**SUBDIVISION REVIEW SHEET (VARIANCE ONLY)**

**CASE NO.:** C8-2015-0053.0A

**SUBDIVISION NAME:** Sunridge Park Section One Lot 1 Block E; Resubdivision

**SUBJECT:** C8-2015-0053.0A Sunridge Park Section 1 Resubdivision Flag Lot variance request

**SUNRIDGE PLAT EXHIBIT**

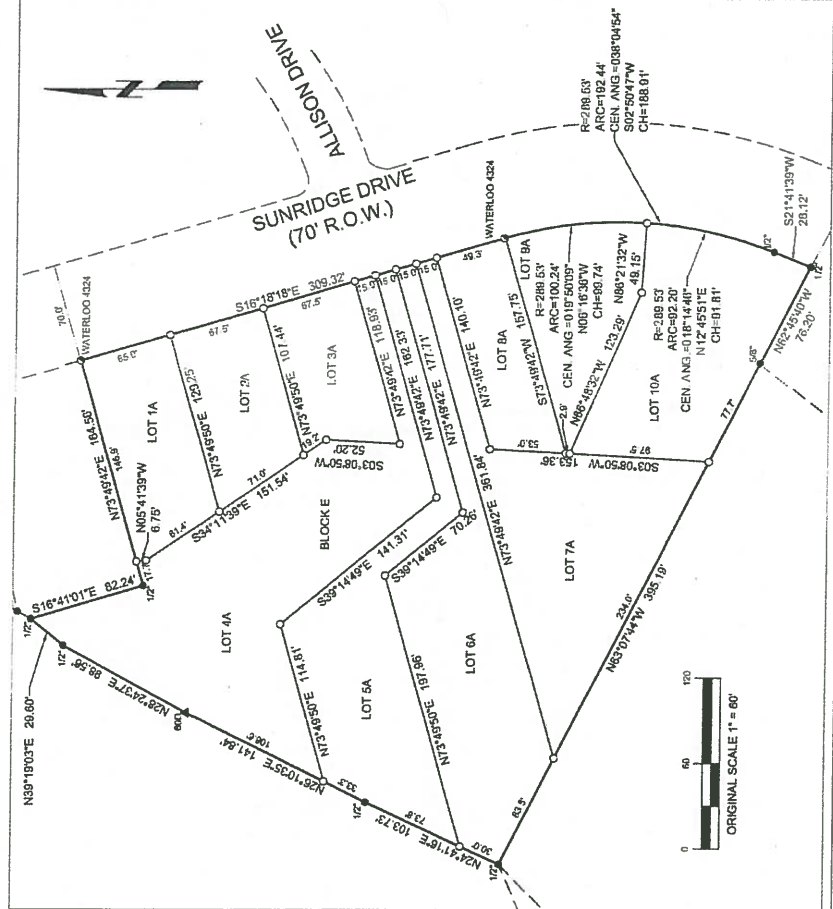
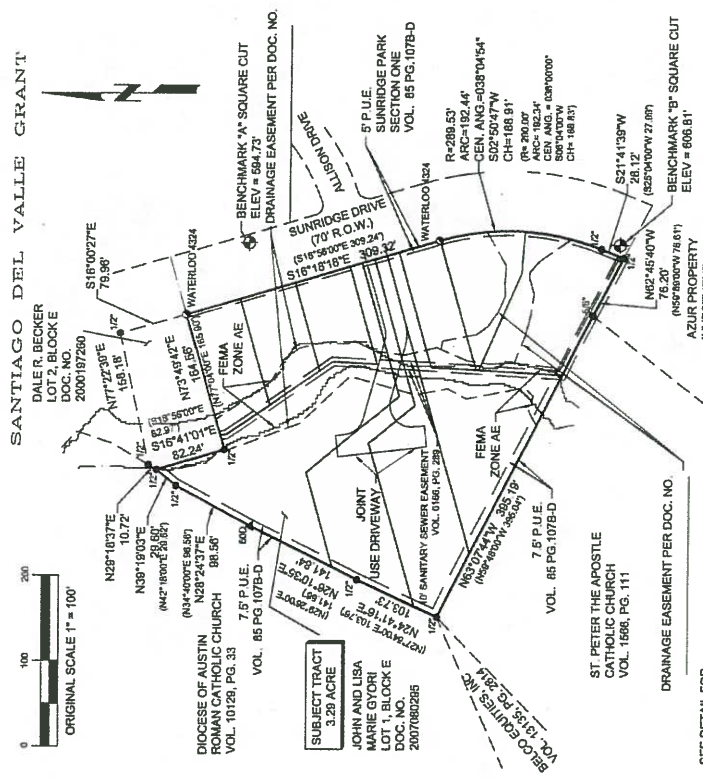
*The applicant has provided a driveway and utility plan to reviewers for the City of Austin Water and Wastewater review and Austin Energy Departments. The reviewers have determined after review of the utility/driveway plan that there is adequate room to provide utility service to both lots and utilities will not cross the proposed new lot lines.*
